## Groundwater Classification - Former Exide Technologies Facility, Frisco, Texas

COMMENTS ON APPENDIX 7 OF AFFECTED PROPERTY ASSESSMENT REPORT,  
FORMER OPERATING PLANT, FRISCO RECYCLING CENTER, FRISCO, COLLIN COUNTY,  
TEXAS (AGREED ORDER DOCKET NO. 2011-1712-IHW-E), PASTOR, BEHLING &  
WHEELER LLC, DATED 7/10/2013

12 SEPTEMBER 2013

12x Vertical Exaggeration

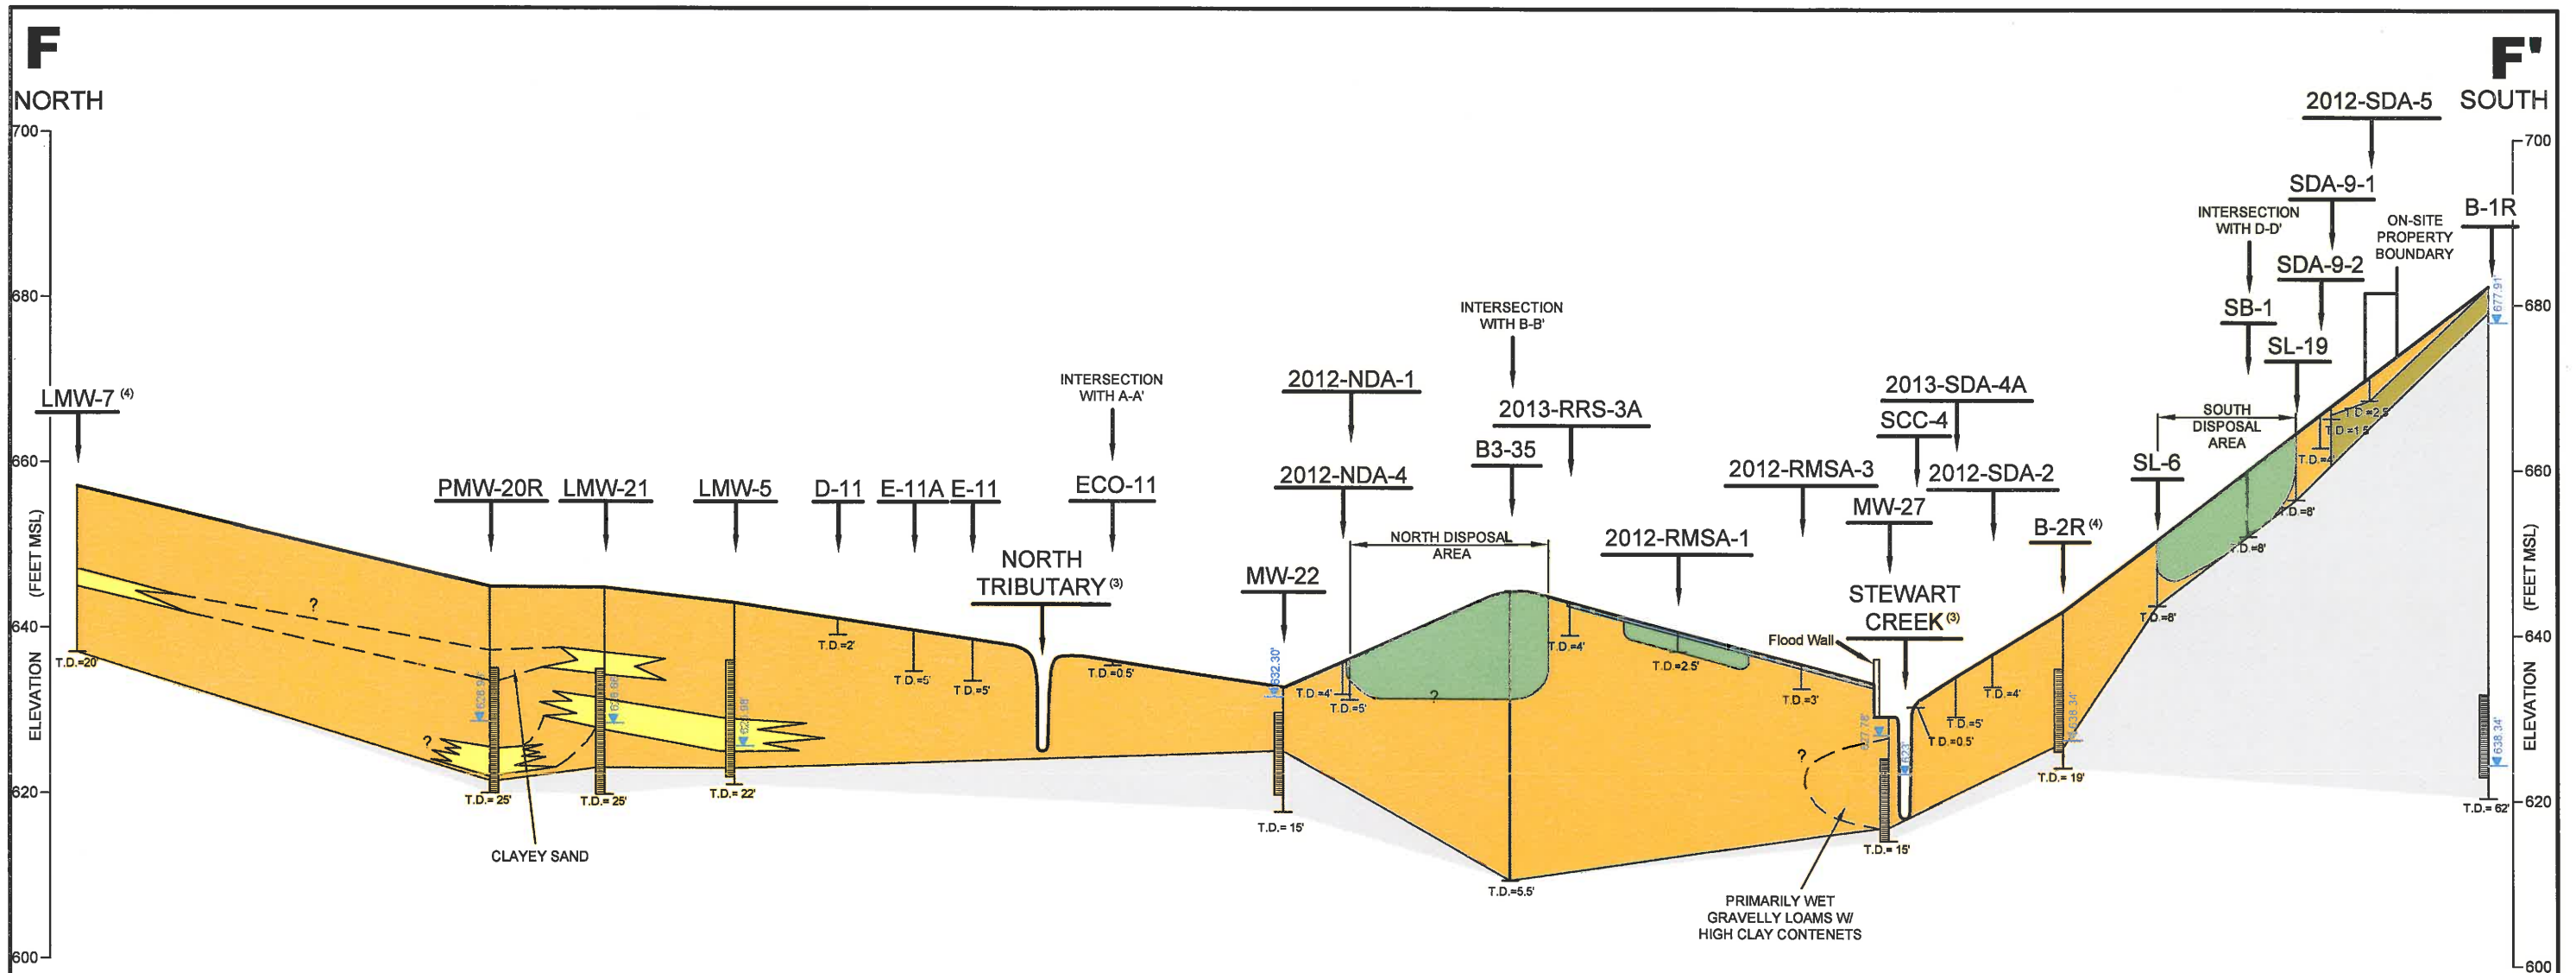
The cross sections that were included with the Groundwater Memo (Sections A-A’ through F-F’) have been revised to illustrate the interpretation of the City’s consultants that connectivity exists between transmissive strata at the site and are attached to this document.

CROSS SECTION G - G'

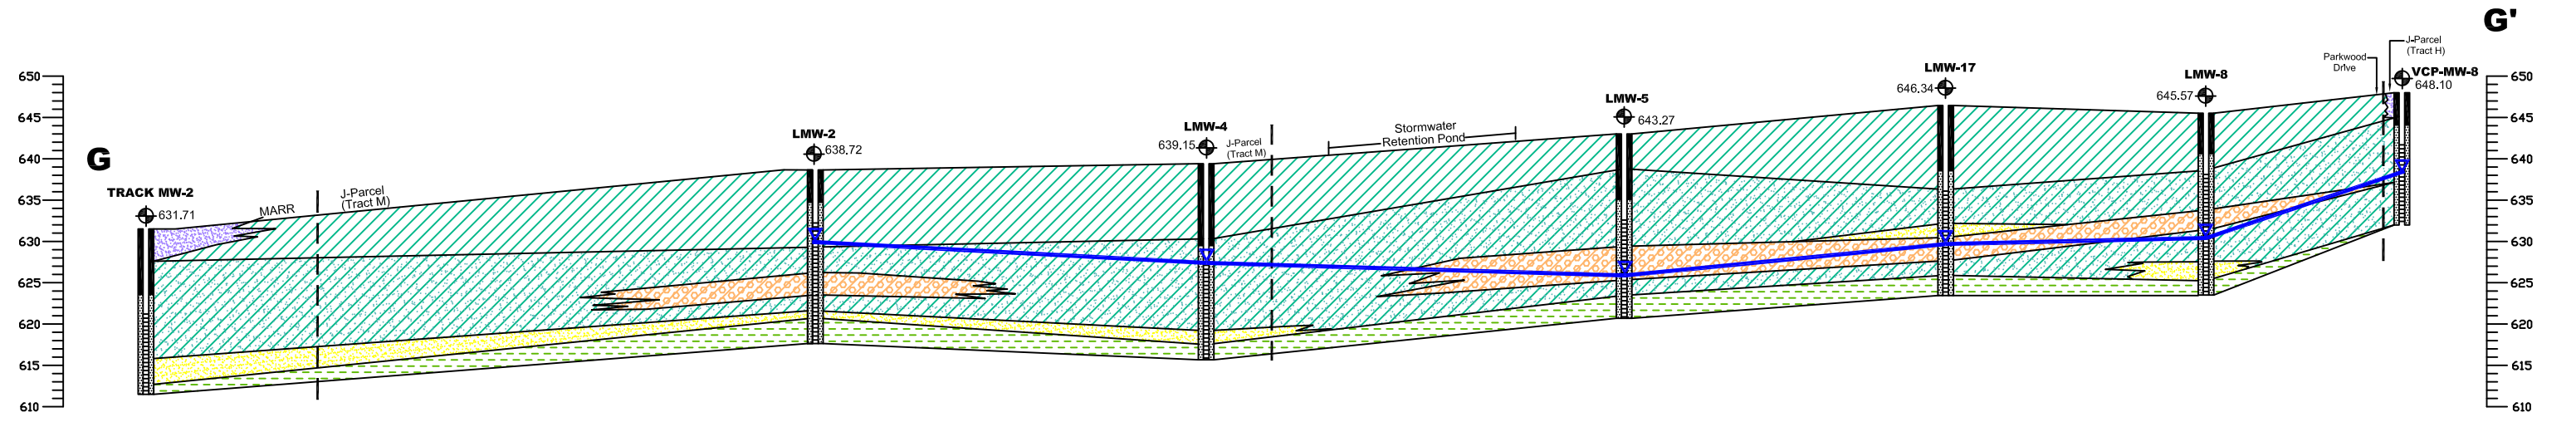
Based on review of the lithologic data presented by PBW, a historic stream channel (a paleochannel) appears to be present within the alluvial deposits at the site. This feature lies immediately to the south of the Class 2 landfill in a roughly east-west orientation, and appears to cross beneath the southeast corner of the Class 2 landfill. The paleochannel contains transmissive soils and, based on a previous groundwater pump test (described below), can produce prodigious amounts of groundwater. However, the apparent paleochannel is not addressed by PBW in its geological and hydrogeological characterization of the site, and the cross sections prepared by Exide for the Groundwater Memo and the APAR to which it is attached did not include a cross section along the paleochannel.

Therefore, a new cross section that generally aligns longitudinally along the paleochannel (Section G-G') has been prepared to depict this feature and is attached to this document. There is a higher percentage of gravel and sand in the paleochannel than in the alluvial deposits outside of the channel.

Figure 9. Unconfined Conditions

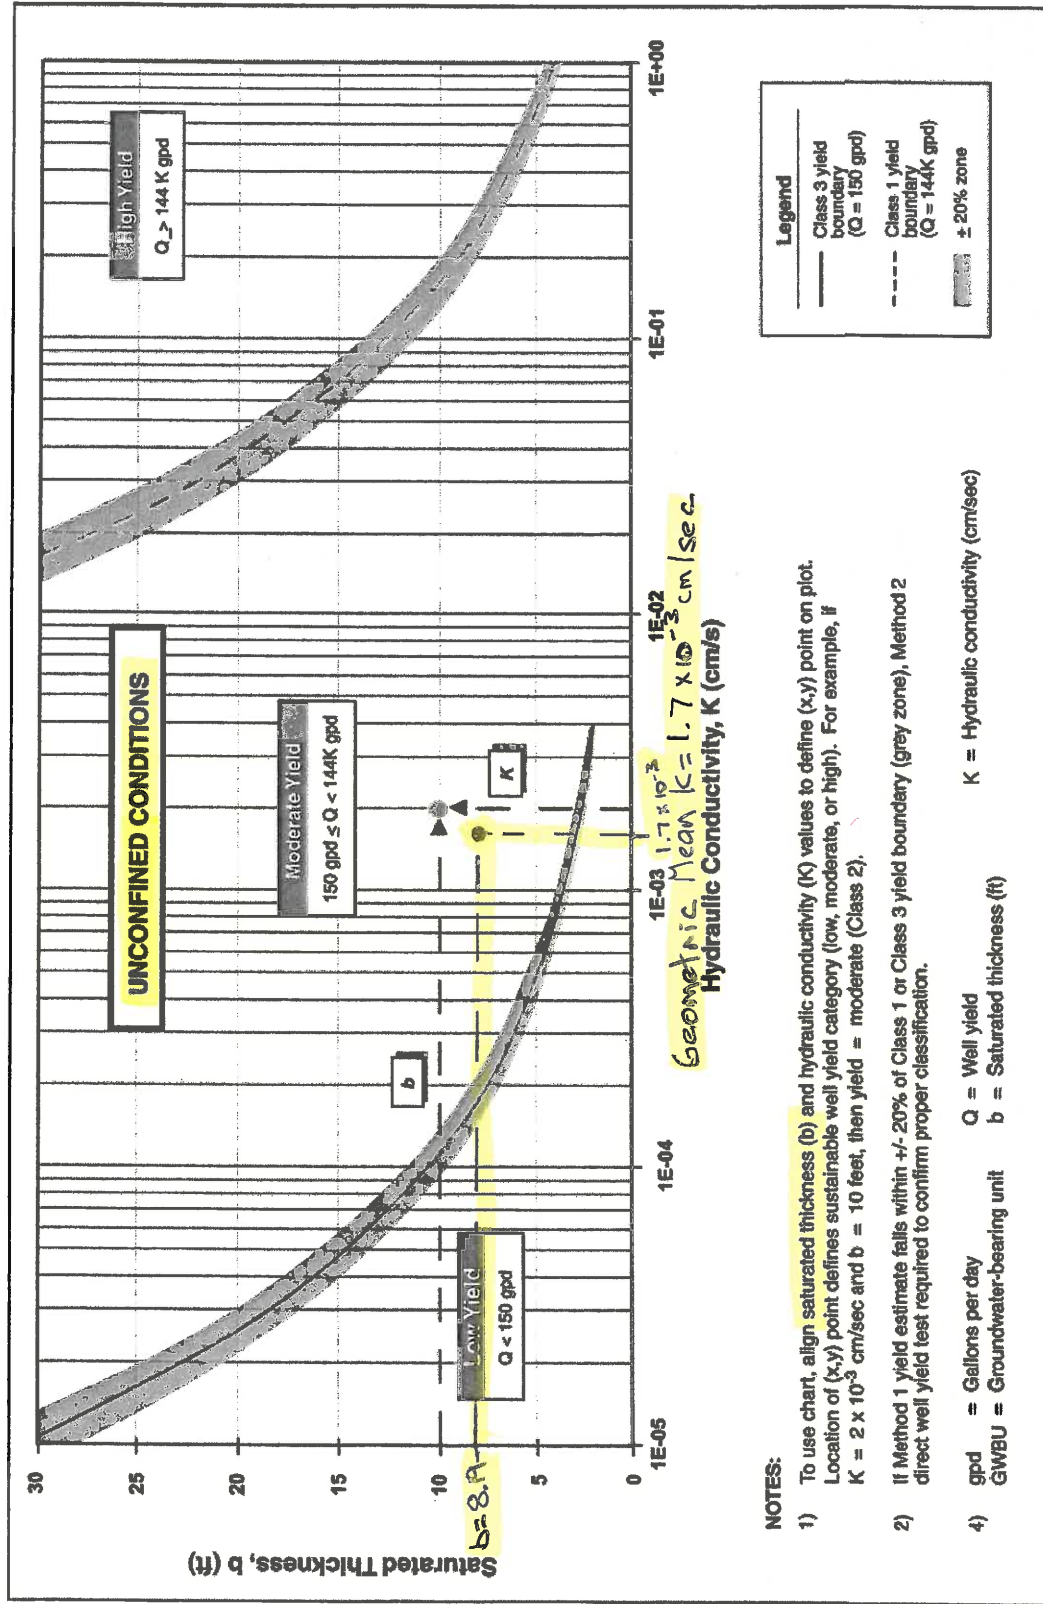
The City agrees that it is instructive to review Figure 9 from TRRP-8. However, in doing so it appears that PBW has performed that comparison incorrectly. In their evaluation, PBW used the average thickness of the "clayey gravels", which would be correct if those "clayey gravels" were considered a confined unit. But the saturated stratum being tested is unconfined. Therefore, PBW should have used the saturated thickness of the groundwater bearing unit being tested, which is clearly spelled out in the instructions for Figure 9 and on page 17 of TRRP-8, which defines saturated thickness as, "For unconfined GWBUs [Groundwater Bearing Units], the saturated thickness (b) at each location is the vertical distance from the static water level elevation to the base of the saturated unit".

When completing Figure 9 from TRRP-8 using the hydraulic conductivity (k) value calculated by Exide for the Bowtie APAR and a saturated thickness of 8.19 instead of 2.0, the City has determined that Exide’s conclusion that the projected yield of these wells falls within the Class 3 boundary is incorrect. Per Figure 9 those wells clearly represent a Class 2 resource and should be treated as such until or unless yield testing performed on them suggests otherwise. The Figure 9 interpretation completed by the City is provided as Attachment C to this document.
